ADDENDUM NUMBER: 5
PROJECT: **UNC Charlotte Residence Hall Phase XIV - Early Site Packages**

DATE: **March 4, 2015**
OWNER: **UNC Charlotte**
ARCHITECT: **FWA Group**

Early Site Package Pre-Bid RFI #1

Early Site Package Pre-Bid RFI #2

**FOUNDATION
DETAILS**

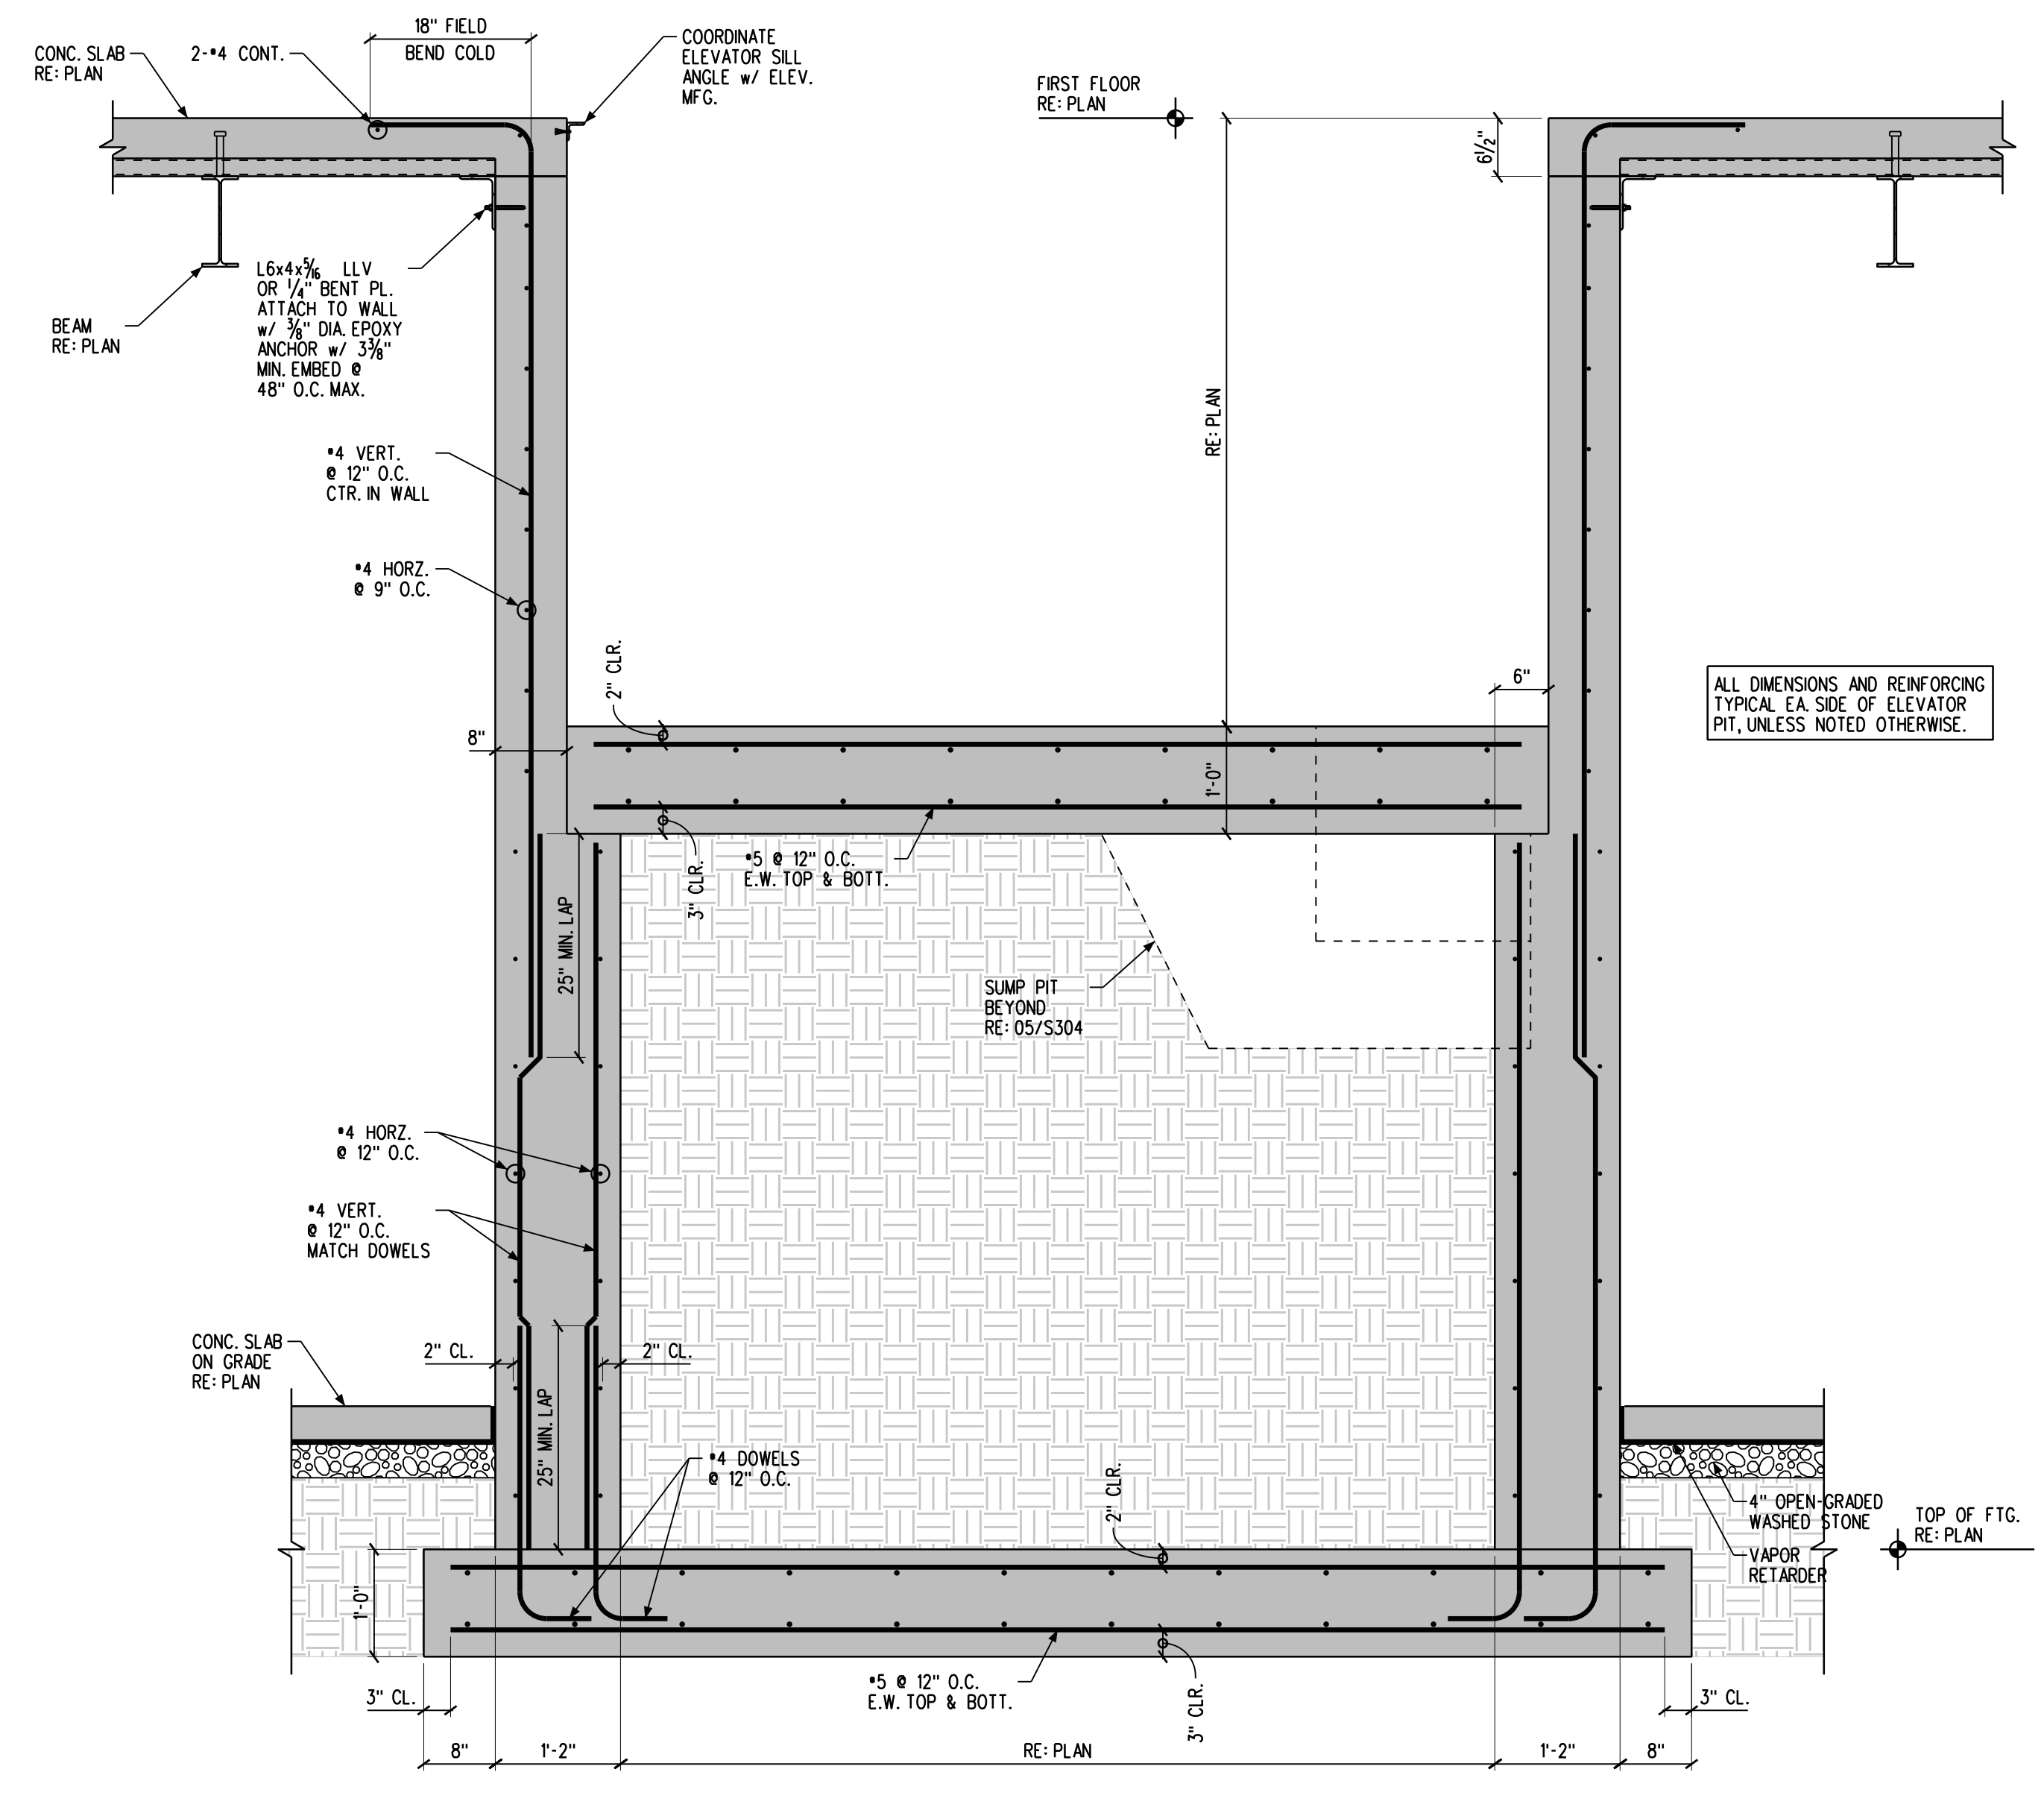
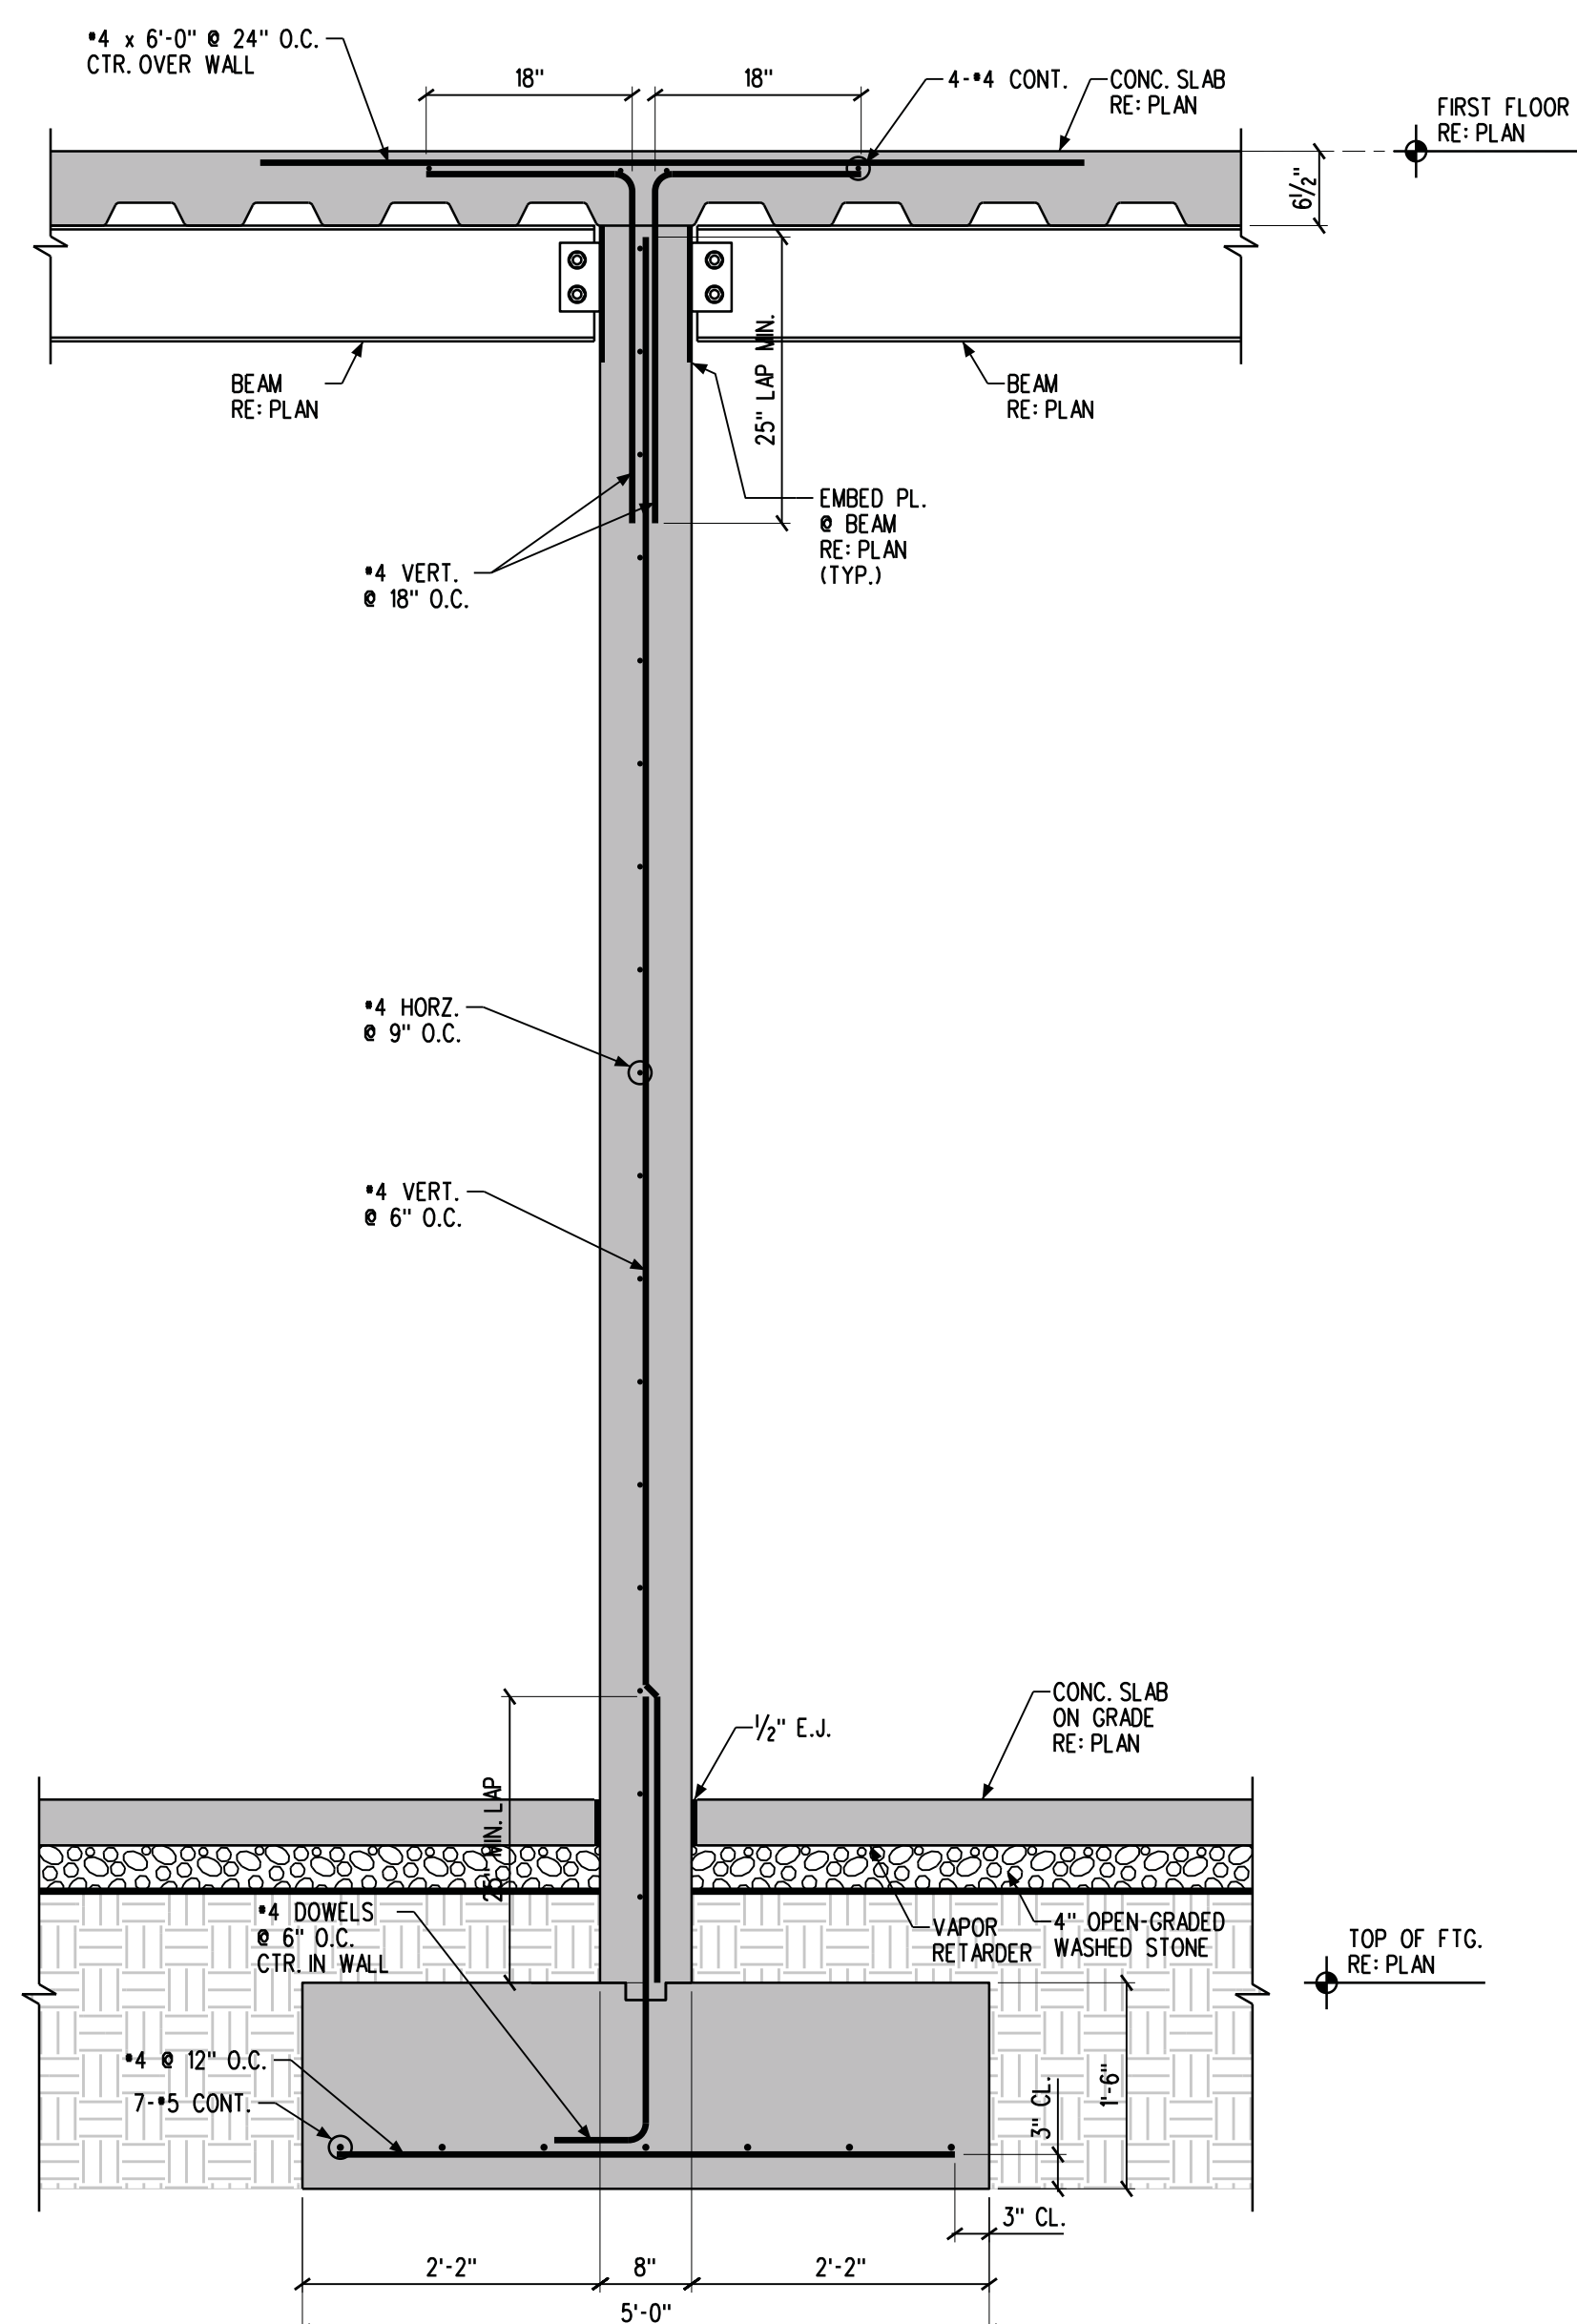
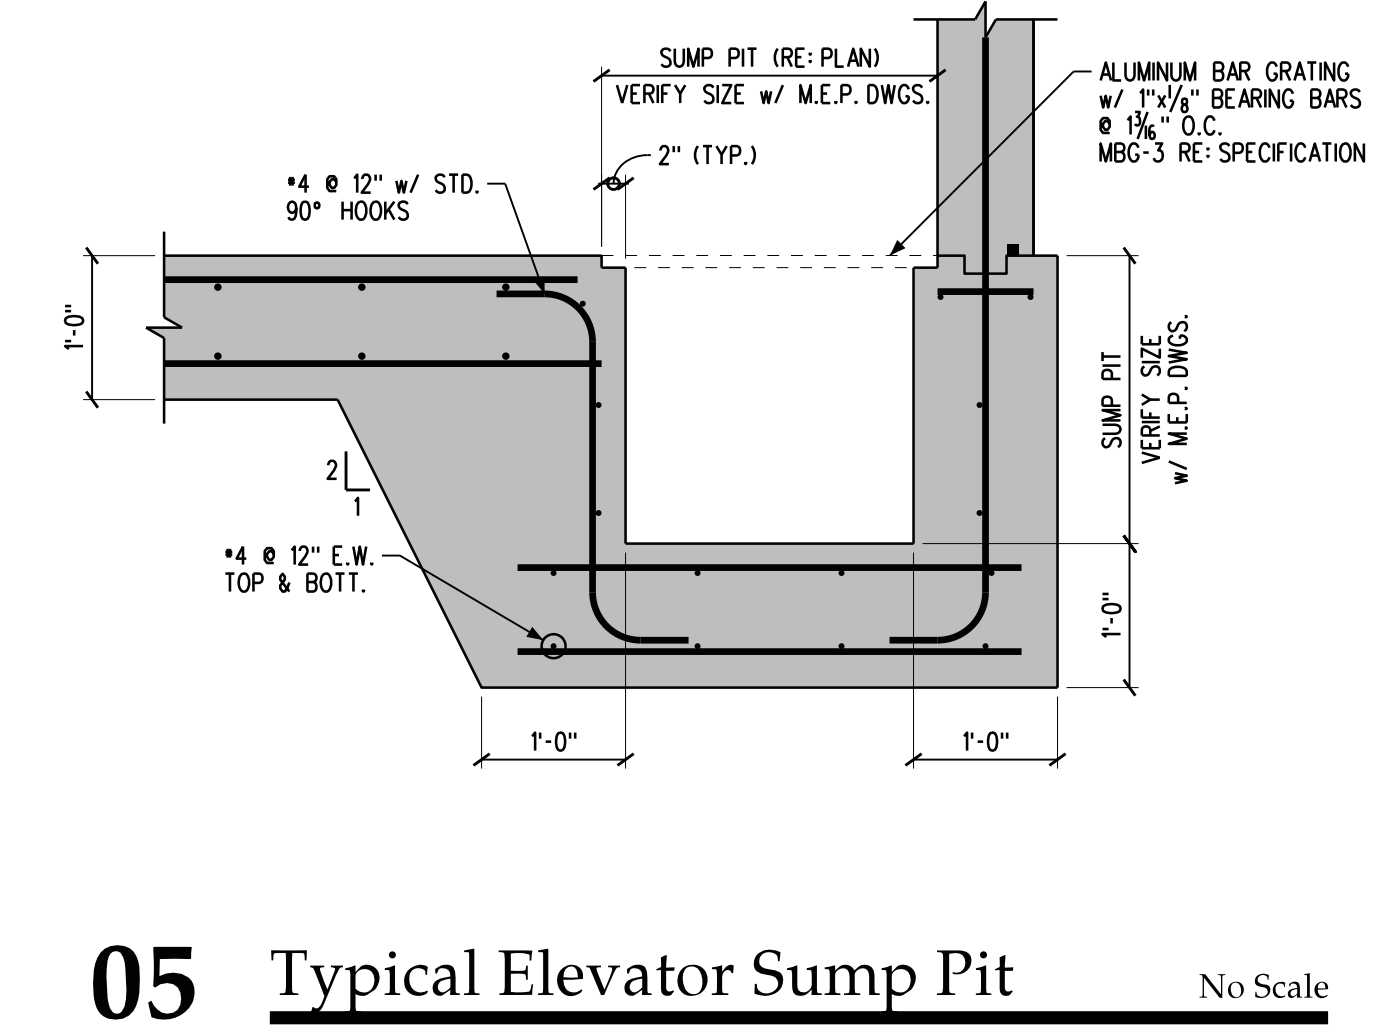
Answer:	FWA Response: Interior waterproofing is not required. The exterior walls of the Central and South Elevator pits are to receive waterproofing per specification 07 13 26 "Self-Adhering Sheet Waterproofing" and as indicated on A2/A710 as part of BP03C.
13	S101-N indicates section 18/S304 at North Elevator Pit- should this be 20/S304?

Answer:	BSDE Response: Details on 01 & 02 on S303 have been revised to eliminate the reference to "first floor". See FWA Addendum #02.
15	Please verify height of central elevator pit walls on S101-N. Section detail 4/S302 shows max height of 6'-6" and does not show a concrete wall extending above slab on grade. However, S201-N indicates a CB1 concrete beam over elevator door at level 1 and the top of adjacent P4A piers are at 731.42. Please confirm if the elevator pit walls should extend to level 1 and provide any required details.

Answer:	BSDE Response: This correction has been made to the drawings. See FWA Addendum #02.
14	Section 2/S303 indicates the top of a foundation wall below the first floor finish floor- please confirm this should be basement slab elevation.

Answer:	BSDE Response: All walls around this elevator extend up to the underside of the first floor. Detail 07/S304 has been added to address this condition. See FWA Addendum #02.
16	Addendum #1, sheet S101-N removed column surrounds in slab leave out areas. Please verify these will not be required in base bid or Alternate #1.
